Re: 1971-1976 Pinto and 1975-1976 Bobcat
Fuel Systems (Except Station Wagons)
Campaign No. 293

SERVICE RECALL BULLETIN

Subject: Service Recall 293, Announcement of a Recall of 1971-76 Pinto and 1975-76 Bobcat 2-Door Sedans and 3-Door Runabouts for Fuel System Modifications.

ATTACHMENT II
RECALL 293

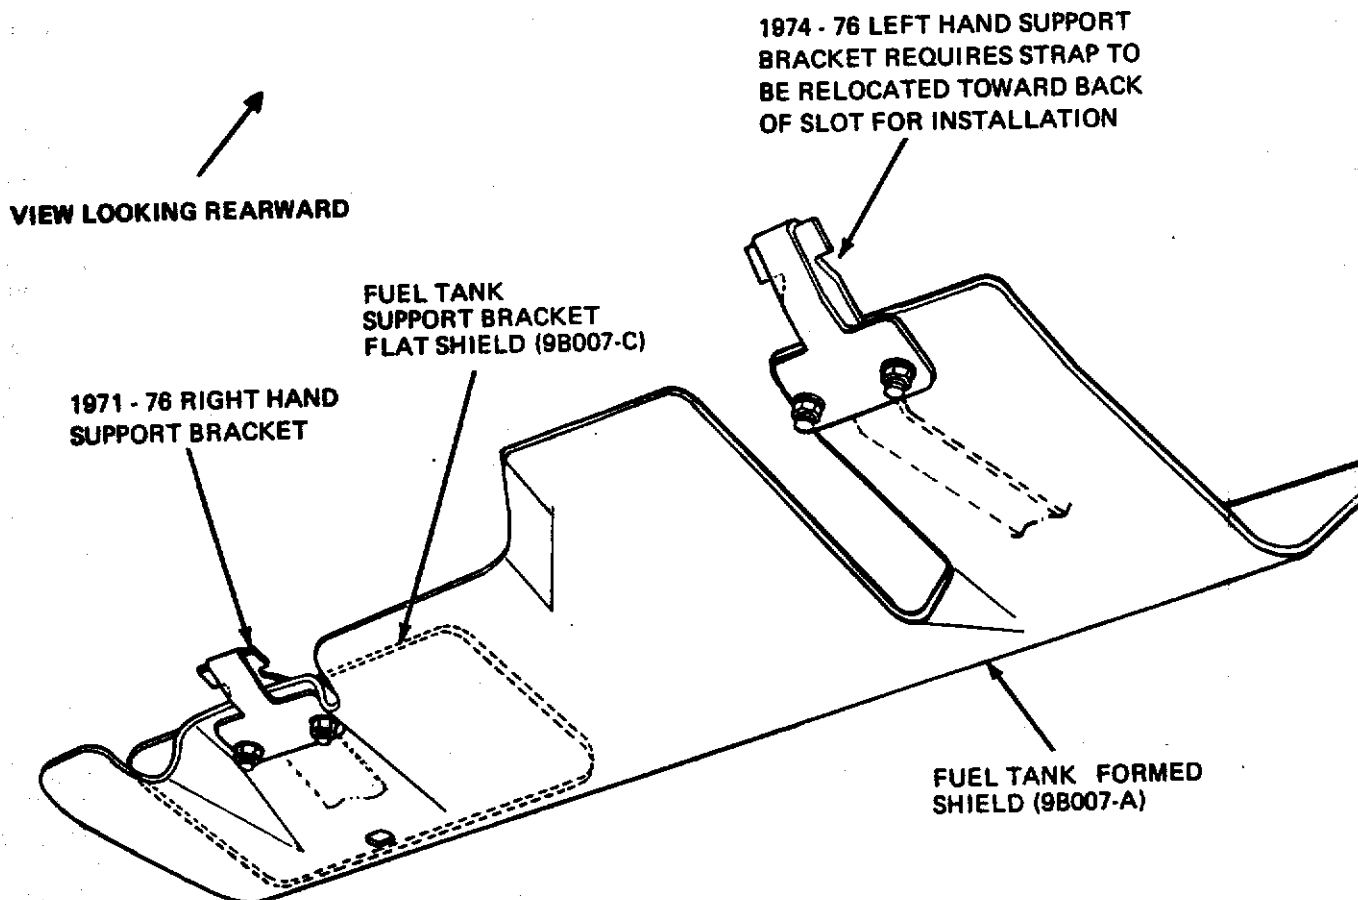
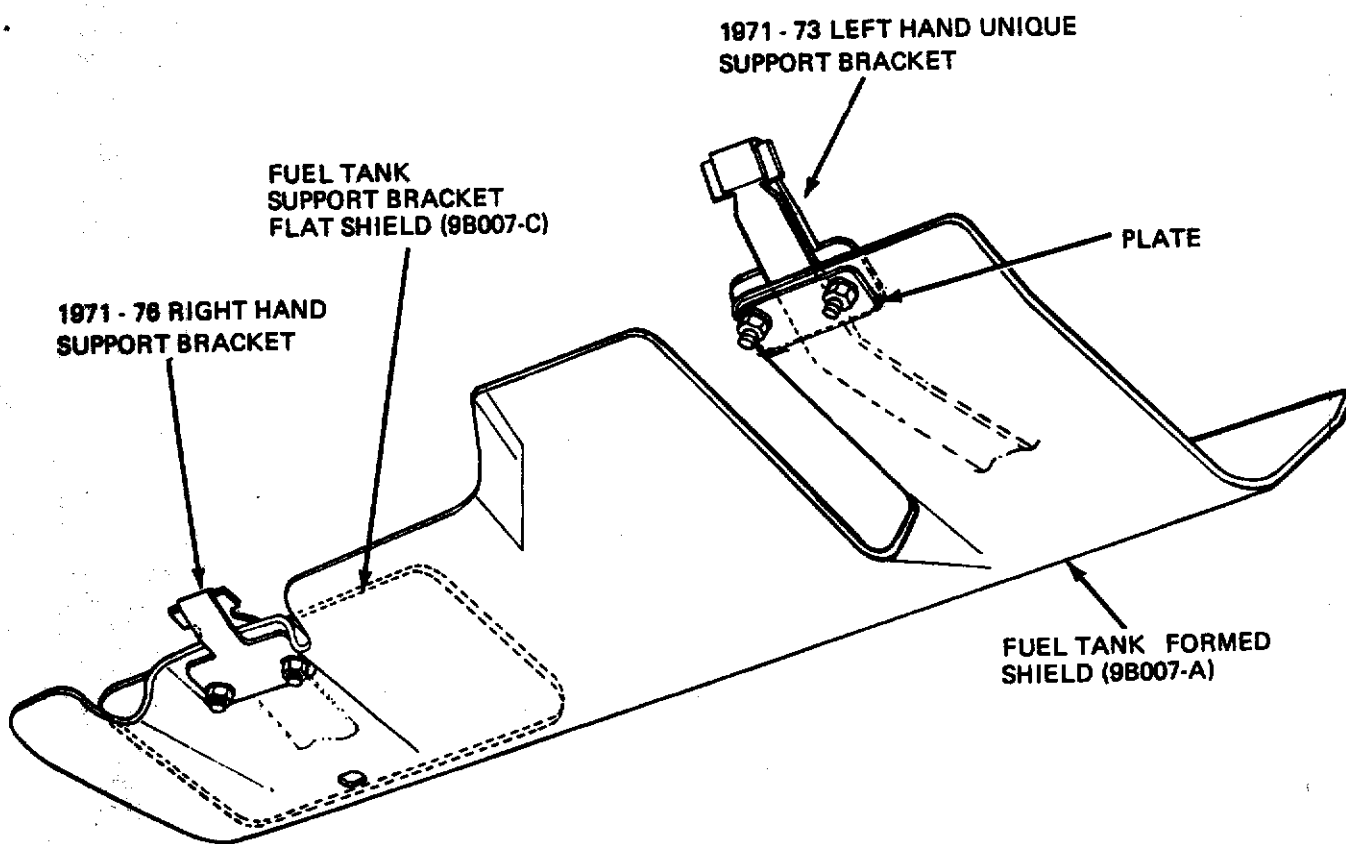
For 1971-73 vehicles - Install the right hand bracket over the fuel tank strap through the slot in the support member with the bracket on the forward side of the strap. Position the flat fuel tank support bracket shield (9B007-C) on the right hand side only as shown in Attachment II. Install the left hand bracket over the end of the strap with the bracket between the tank and strap. Install the U-bolt through the left hand bracket from the rear of the bracket. Install the formed fuel tank shield (9B007-A) on the left hand U-bolt holes as indicated on the shield. Install plate on left hand U-bolt and thread nuts. Complete the installation as shown in Attachments II, III and IV by installing the U-bolt around the rear of the right hand strap and through the shield and bracket (no plate required for right hand U-bolt).

For 1974-76 vehicles - Install the right and left hand brackets on the forward side of the strap as shown in Attachment II. The left hand strap must be pushed toward the back of the slot to allow installation of the bracket. Position the fuel tank support bracket shield (9B007-C) on the right hand side only as shown in Attachment II. Install the fuel tank shield (9B007-A) as shown in Attachments II and III, using the left hand holes indicated for 1974-76 (the 9B223 plate is not used for shield installation on these vehicles).

SHIELD INSTALLATION

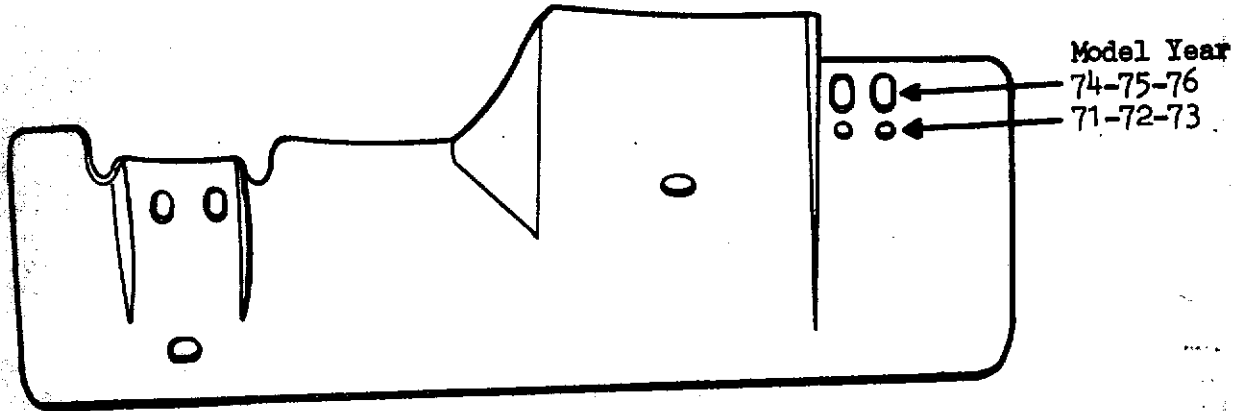
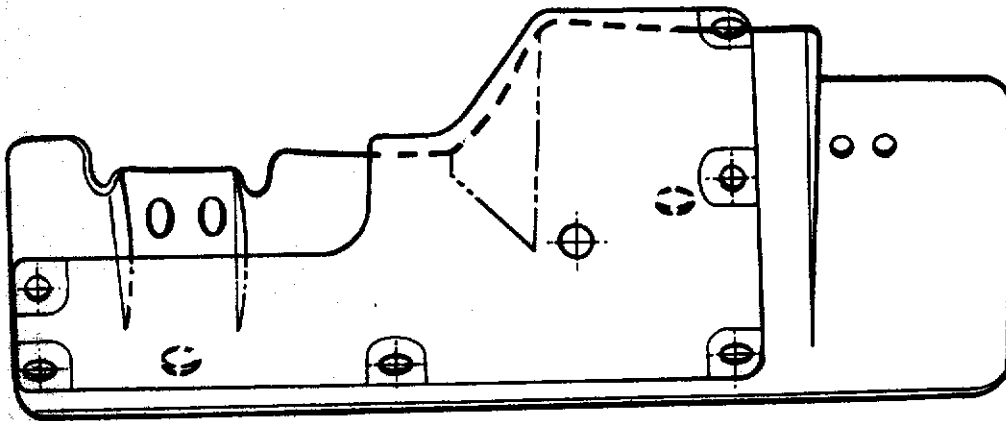
NOTE: 1975 vehicles with dual exhaust require a unique fuel tank shield (9B007-A) as shown in Attachment V. On all 1971-76 vehicles the fuel tank support bracket shield (9B007-C) is installed on the right hand side only and between the fuel tank strap and fuel tank shield (9B007-A).

**ATTACHMENT VI
RECALL 293**

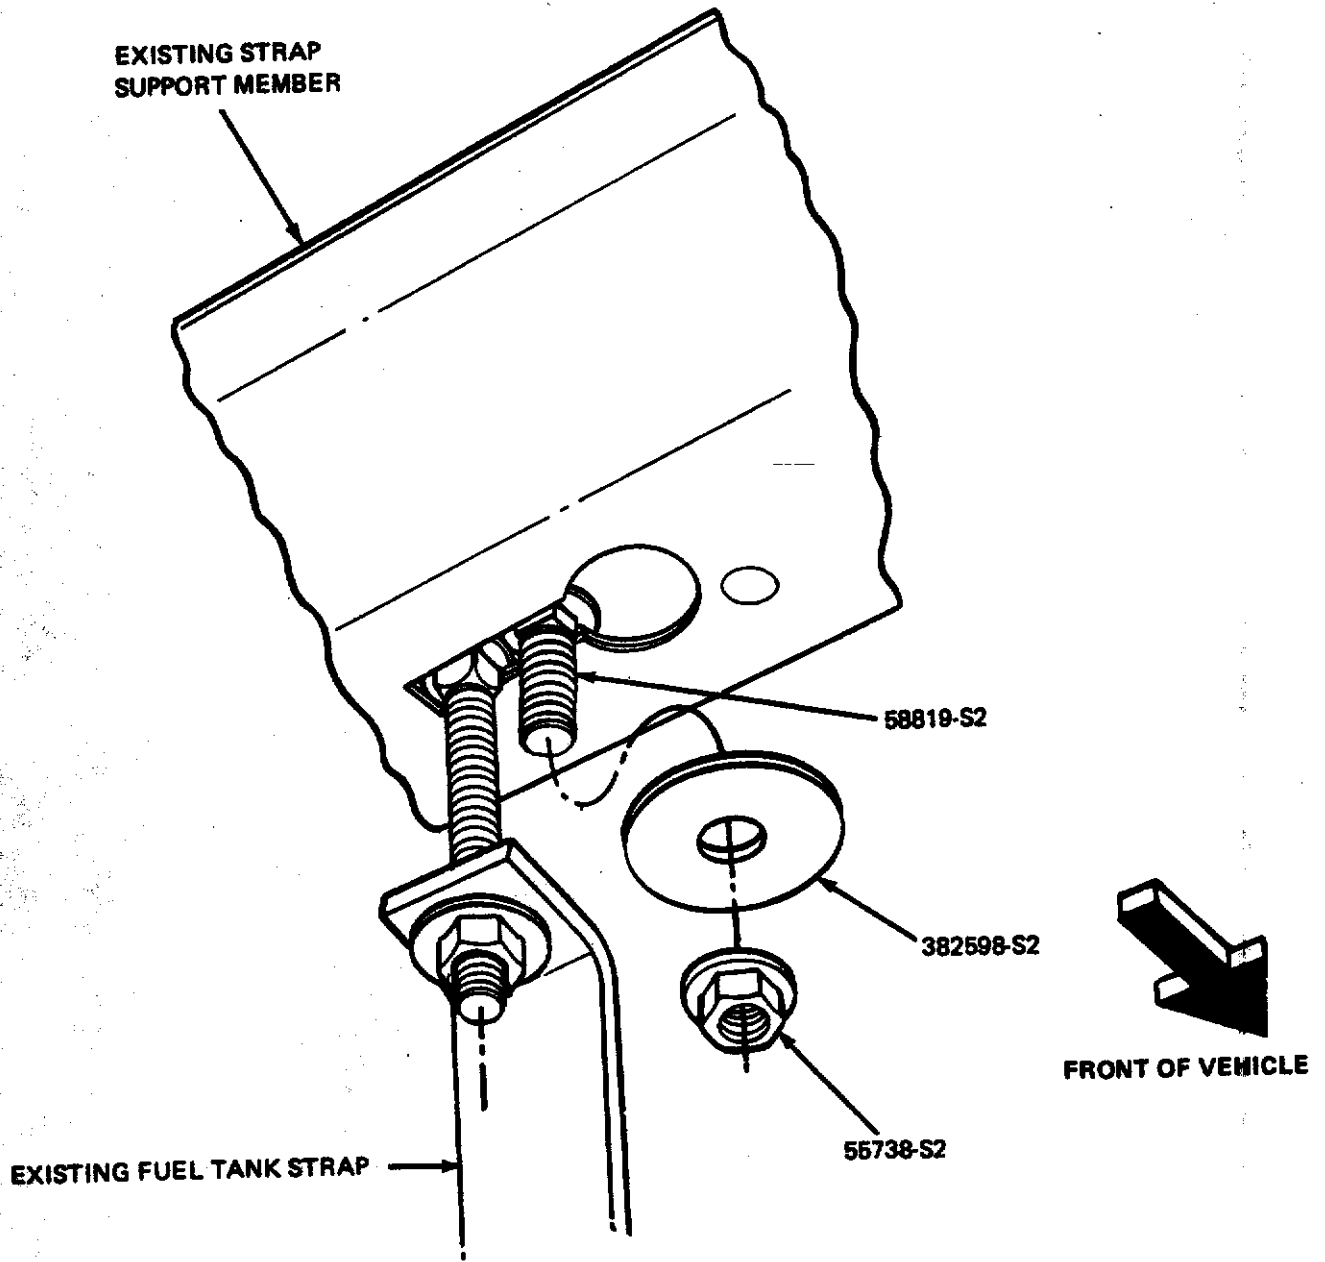
4. Attach bolt service part number (58819-S2), flat washer service part number (382598-S2) and nut service part number (55738-S2) to the strap support member on the left hand side of 1971-73 vehicles. On 1974-76 vehicles the above bolt, washer and nut are attached to both right hand and left hand sides of support member. Refer to Attachment VI.

NOTE: If the existing strap support member attaching bolt is not located at the square end of the slot in the support member, relocate the bolt toward the square end making sure square shoulder of the bolt (58819-S2) is in the slot. Torque to 20-30 ft. lbs.

LEFT REAR QUARTER PANEL

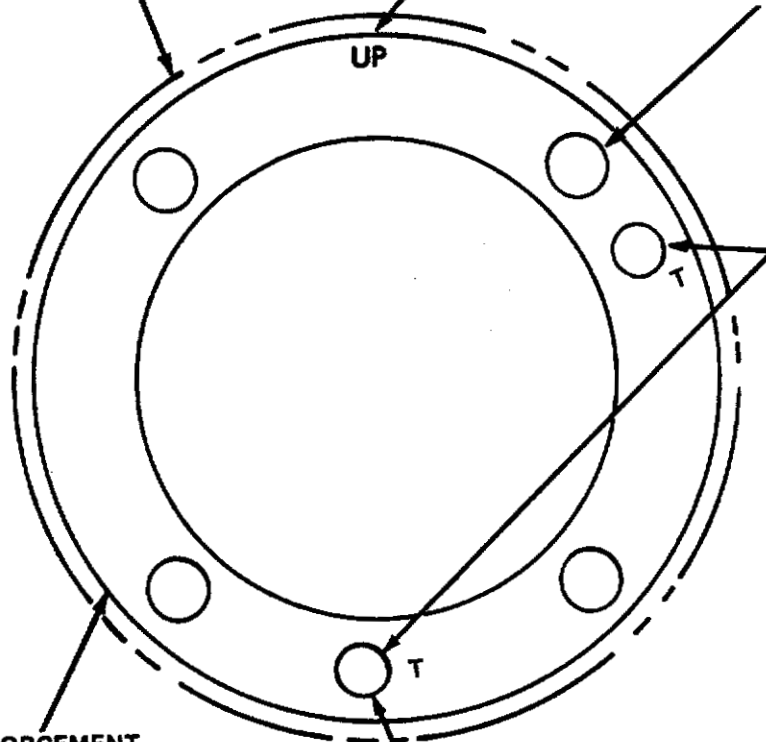
4. To contain fuel vapors and to keep the fuel tank clean, place body tape over the opening in the tank to seal it completely.
5. Align the (2) holes identified with "T" in the reinforcement (9B211) with (2) of the (3) existing holes in the fuel filler pipe opening in the quarter panel. The word "UP" should be visible from outside the vehicle and indexed as indicated in Attachment VIII. Install (2) of the (3) existing 9/32" sheetmetal screws removed in Step 3 above to hold the reinforcement in place.

6. Drill (4) 5/16" diameter holes in the quarter panel using the reinforcement as a template. If fuel vapors are present, DO NOT use electric drill until vapors can be dispersed.

10. Align the reinforcement (9B211) with the previously drilled 5/16" diameter holes in the quarter panel opening. Refer to Step 6. Be sure that the gasket (9076) and filler pipe flange are also aligned with the drilled holes. Secure the entire assembly to the outside quarter panel opening with (4) screws (388275-S2).

ATTACHMENT IX
RECALL 293

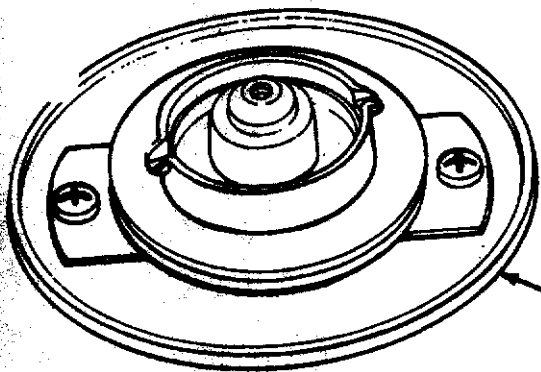
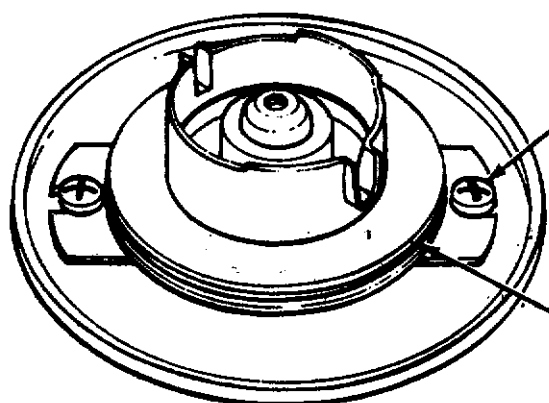
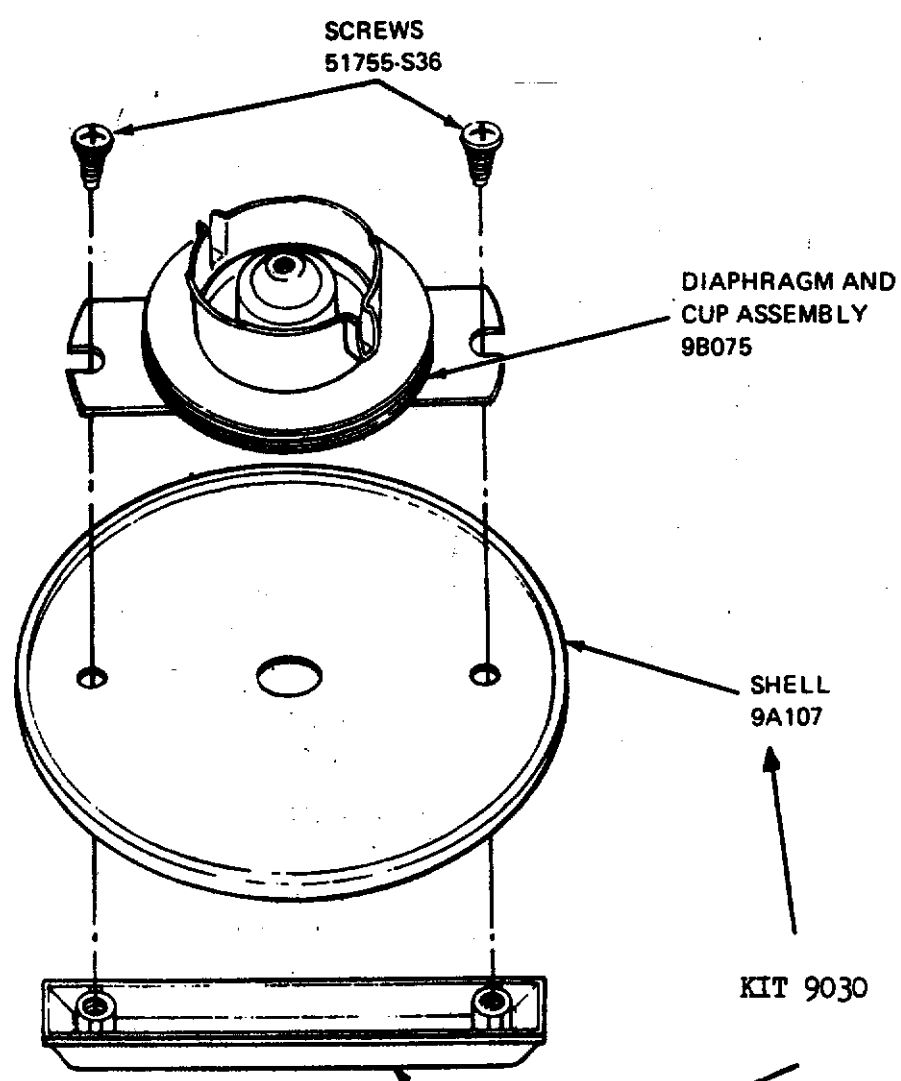
For non-locking original equipment fuel filler pipe cap replacements, (see Attachment IX), remove the (2) existing screws which attach the diaphragm and cup assembly, and install the new diaphragm and cup assembly (9B075) in the existing shell using (2) new screws (51755-S36).

If the cap is a locking or other aftermarket cap, it is to be replaced. (See Attachment IX). Remove the cap from the filler pipe and place it in the passenger compartment of the vehicle. Assemble the new diaphragm and cup assembly (9B075) to the new filler cap shell and handle kit (9030).
